MISSISSIPPI POWER & LIGHT COMPANY

October 19, 1982

SUBJECT: Grand Gulf Nuclear Station
Units 1 and 2
Docket Nos. 50-416 and 50-417
License No. NPF-13
File 0260/L-814.2/M-001.0
SQRT Qualification of the
Hydraulic Control Units
Affected by Variable Pool
Swell Loads - SSER 3,
Section 3.10
AECM-82/494

Figure 1, TRS and RRS in the vertical direction at HCU floor for Faulted condition

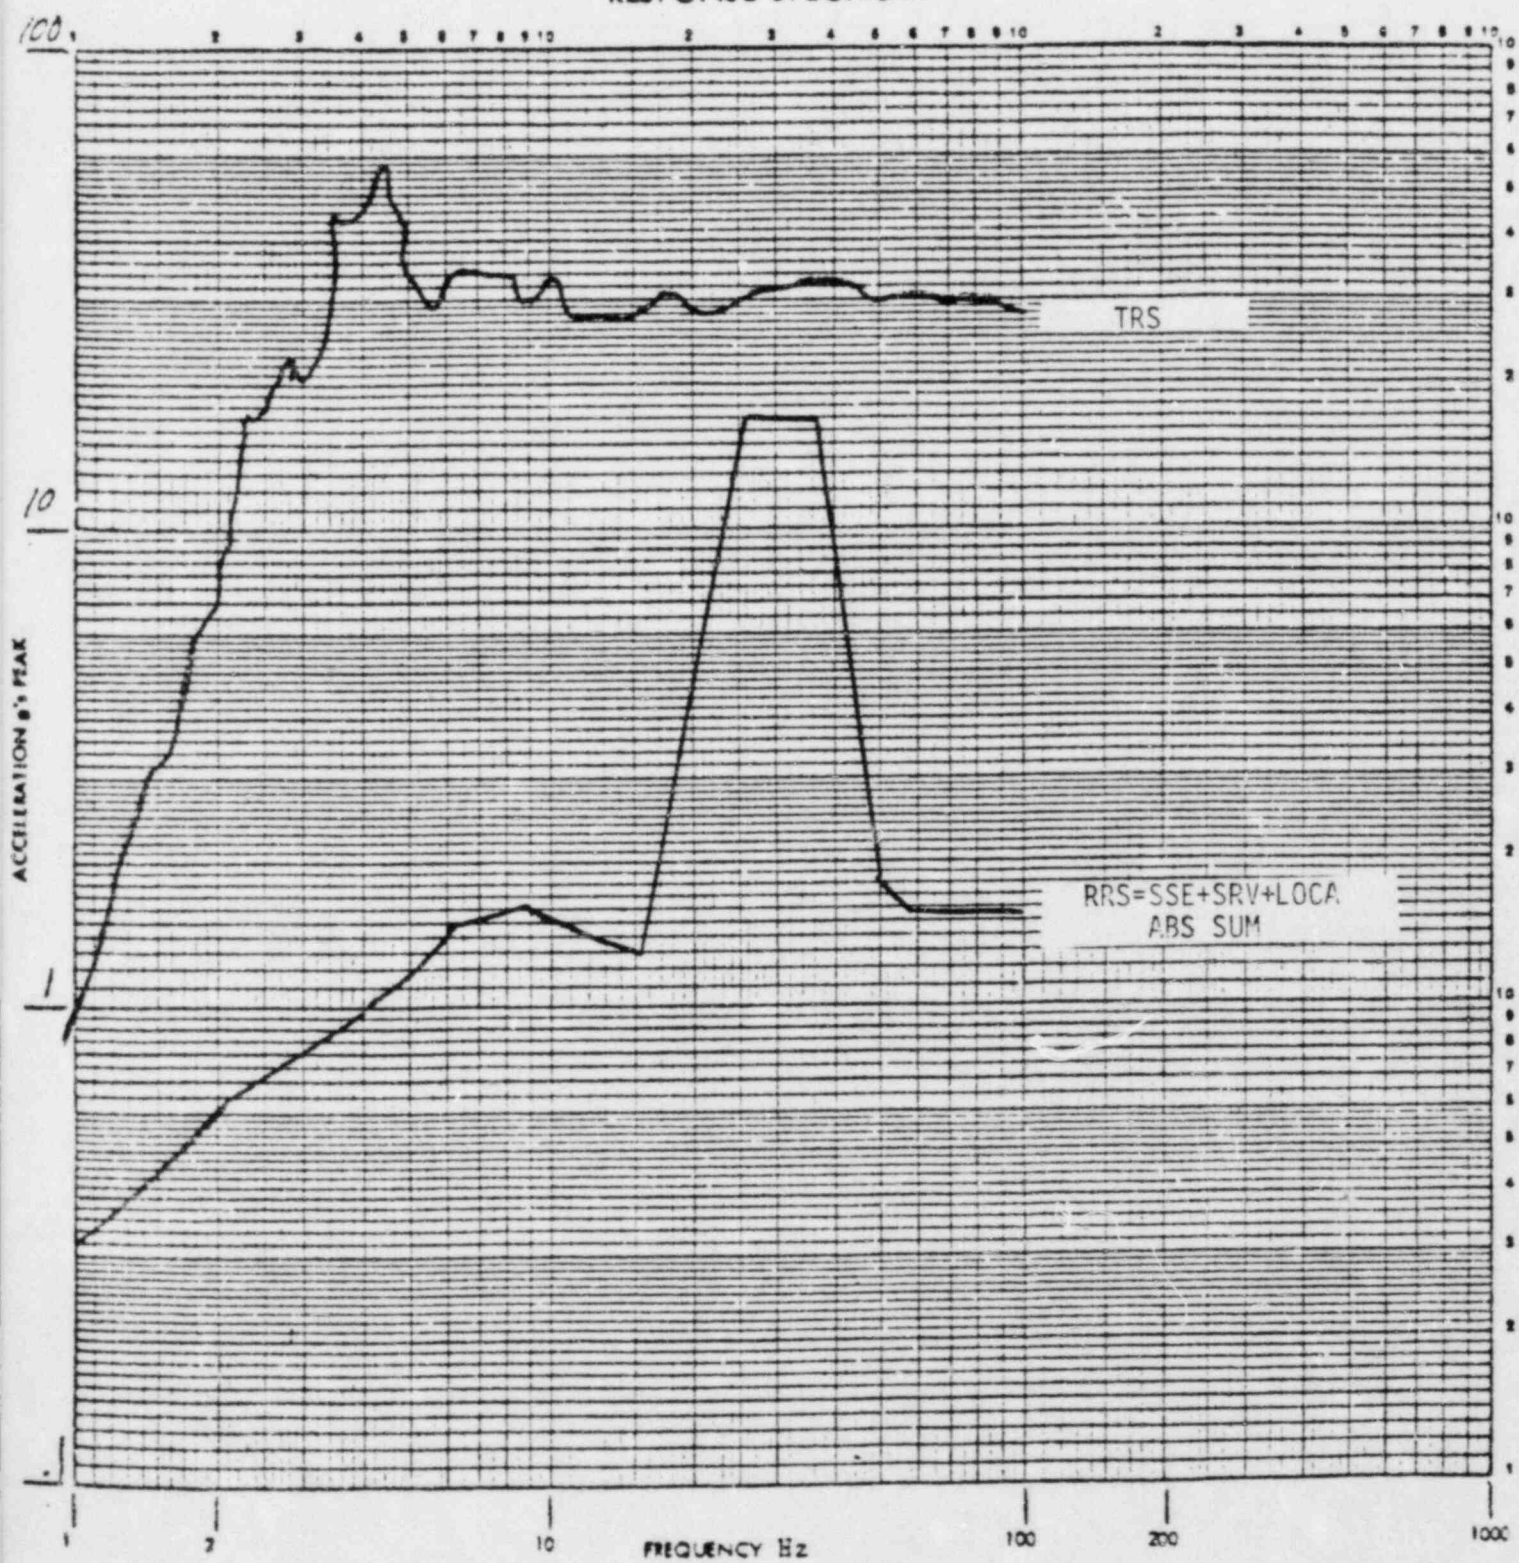
The attached figures show that the HCU RRS is enveloped by the test response spectra (TRS). Only figures for the horizontal directions are provided for the upper attachment point because the HCUs are relatively stiff in the vertical direction and minimal TRS amplification is expected.
